## Re: API # 045-07440, Verbal for a Water Squeeze

**GM 34-14**  
**SWSE 14 7S 96W**  
**Grand Valley**  
**05-045-07440**

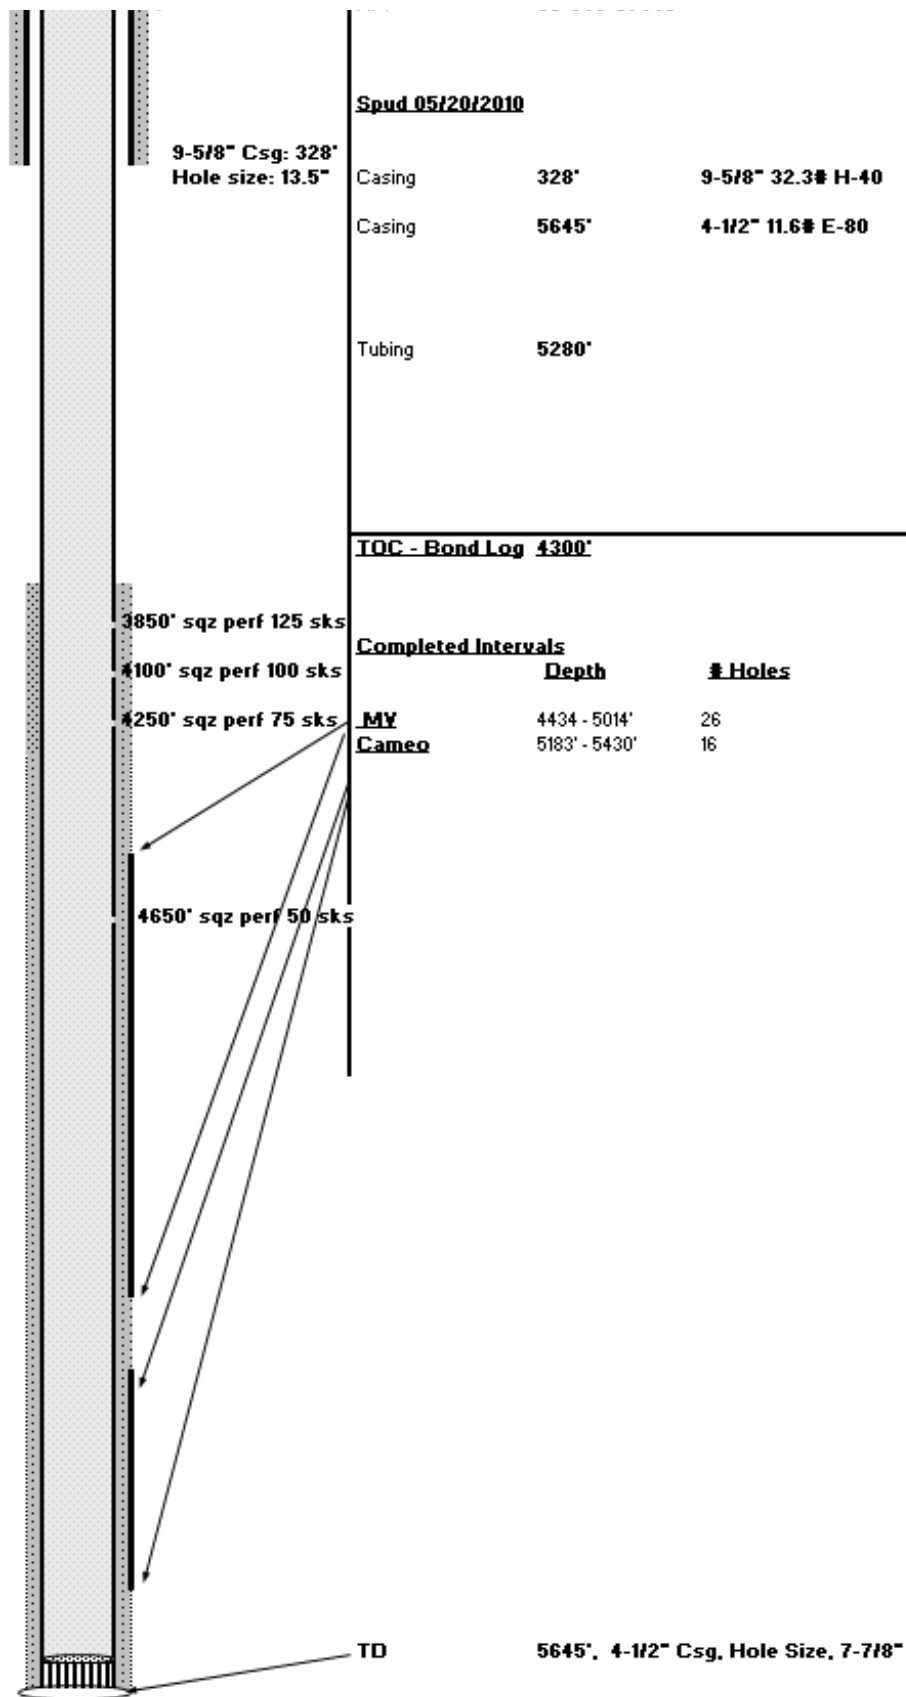
WPX is requesting a Verbal for a high-water producing perforation interval cement squeeze, below and attached is the procedure and wellbore diagram:

MIRU sevice rig, POOH w/ 2-3/8" tbg

RIH with RBP, set at 4380' with 2 sks sand to isolate perforations, pressure test 4-1/2" csg to 1000 psi

If pressure test fails, squeeze failing area with cement

If pressure test passes, re-set RBP at 4680', POOH and PU packer, set at 4400' and swab test to identify high water producing interval

Squeeze high water producing interval with cement, WOC 24 hrs

RIH with tubing and bit, drill out cement and pressure test squeezed perforations to 1000 psi

Clean out wellbore, re-land tubing and return to production

Though this well is 'technically' in Mr. Burger's area – I believe that he, too, would grant verbal approval to conduct the proposed operations. I will document this with this email approval in the well-files.
